U. S. NUCLEAR REGULATORY COMMISSION  
OBSERVATION AUDIT REPORT  
FOR THE  
NEVADA NUCLEAR WASTE STORAGE INVESTIGATIONS PROJECT  
AUDIT NO. S89-1 OF  
HOLMES AND NARVER

H&N DESIGN PROCESS  
(ENCLOSURE 1)

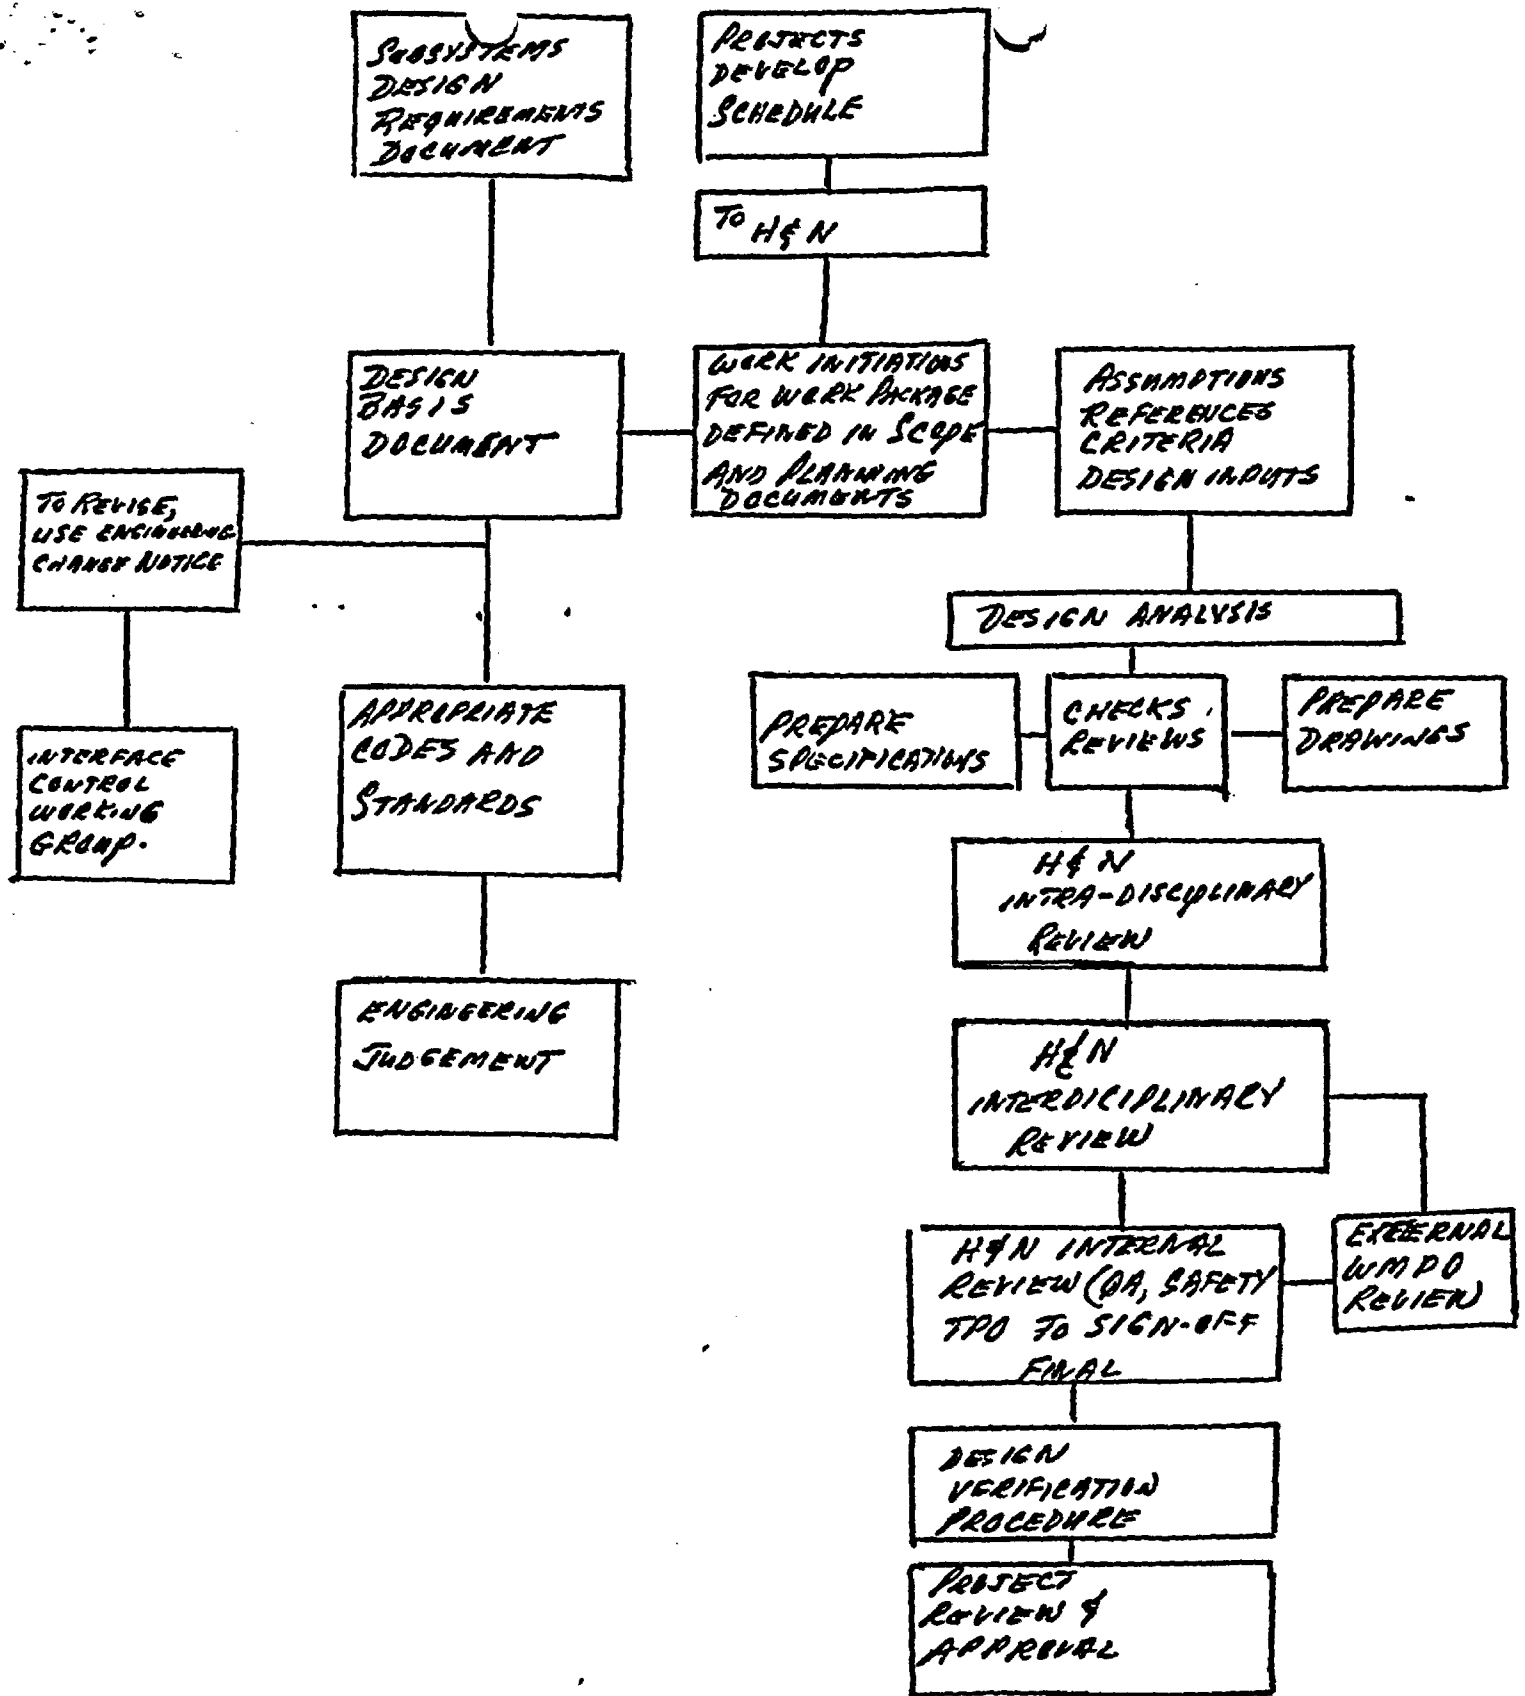
H&N explained to the NRC staff how the design process is implemented from start to finish (See Enclosure 1). For certain phases of the process, there were measures to control and implement changes to a particular design. However, there did not appear to be any controls to assure that if any portion of the design were changed, that the effects of this change would be considered on the overall design. The NRC staff believes the audit team should have reached this conclusion. This was brought to the attention of the audit team prior to the exit meeting and indicated it would be noted in the NRC Observation Audit Report.

The H&N staff explained how their overall design process is implemented from start to completion (see Enclosure 1). The NRC staff observed that if any portion of this design were changed, there were no definitive controls covering the impact of this change on other aspects of the design. In this regard, consideration should be given to develop controls to improve this area. It appeared to the NRC staff that the audit team did not reach this conclusion. (Section 4.4)
